C2022042

**BUILDING CODE OF AUSTRALIA
2022 REPORT**

**27 REDMAN ROAD
DEE WHY NSW**

Residential Flat Building

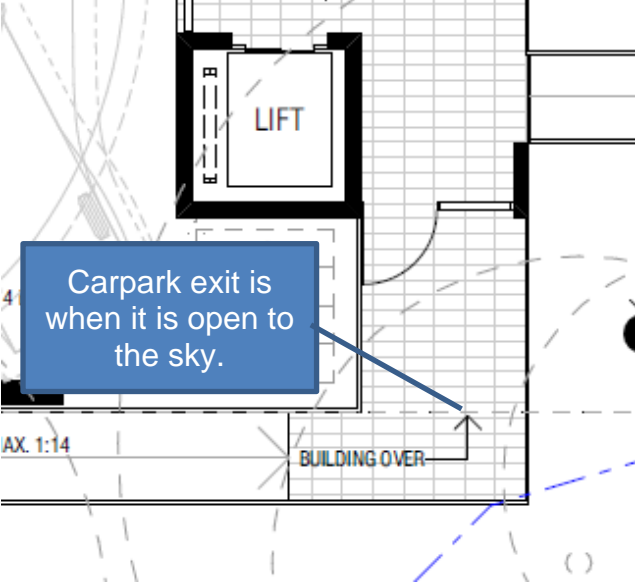
No.	Recommendation	DTS Clause
1	<p>Within Building 'A' spandrel separation is required from the carpark to level 1 and from level 1 to level 2.</p> <p>Western openings (metal grill) to ground floor Building "A" marked in red below.</p>  <p>Western openings (1 x door and 1 x window) to first floor Building "A" marked in red below.</p>  <p>Western openings (4 x window) to first floor Building "B" marked in red below.</p> 	C4D3
2	One hand rail is required to all stairs as per this clause. The two non-fire isolated stairs must have two hand rails to AS 1428.1-2009 and are subject to detailed design at construction certificate stage.	D3D22
3	Disabled access must be provided from the principal pedestrian entry at the property boundary to the:	D4D4

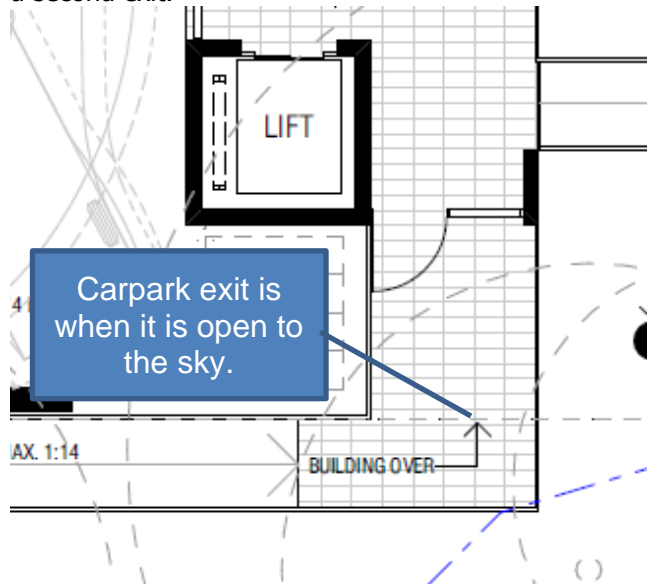
C3D1	DtS Provisions.	Applicable <i>performance requirements</i> for <i>building solutions</i> .	Note only
C3D2	Application of Part.	Applicable Yes or No	Applicable
C3D3	General floor area and volume limitations.	The maximum floor areas and volumes do not apply to Class 2 parts or sprinkler protected car parks.	Yes
C3D4	Large isolated buildings.	Not a large isolated building.	N/A
C3D5	Requirements for open space and vehicular access.	Not a large isolated building.	N/A
C3D6	Class 9 buildings. NSW C3D6(3) relating to Class 9c buildings.	Not a class 9 building.	N/A
C3D7	Vertical separation of openings in external walls.	<p>Spandrel separation is required as the building requires Type A construction and is not proposed to be sprinkler protected.</p> <p>Spandrel separation must be one of the following: (A) is not less than 900 mm in height; and (B) extends not less than 600 mm above the upper surface of the intervening floor; and (C) is of non-combustible material having an FRL of not less than 60/60/60; or</p>  <p>FIGURE 4 - VERTICAL SEPARATION IN TYPE A CONSTRUCTION (SPANDREL)</p>	Yes

<p>FIGURE 5 - HORIZONTAL SEPARATION IN TYPE A CONSTRUCTION</p> <p>Within Building 'A' spandrel separation is required from the carpark to level 1 and from level 1 to level 2.</p> <p>Within Building 'B' spandrel separation is required from the lobby / storage area to level 1, and from level 1 to 2.</p>	
C3D8	Separation by fire walls.	No <i>fire walls</i> separating the building in different <i>fire compartments</i> .	N/A
C3D9	Separation of classifications in the same storey.	Not applicable as each storey is one class only. Not the basement	N/A
C3D10	Separation of classifications in the different storey.	The ground floor is Class 7a, while level 1 is Class 2. and the ground floor is class 2. As such, the first floor slab must have the higher FRL of 120 minutes for the Class 7a instead of 90 minutes for the Class 2.	Yes
C3D11	Separation of lift shafts.	<p>The lift shafts must be fire rated and achieve an FRL of:</p> <ul style="list-style-type: none"> - 120/120/120 to ground floor level; - 90/90/90 on remaining levels. <p>Doorways to the lift are to have an FRL of --/60/--.</p>	Yes
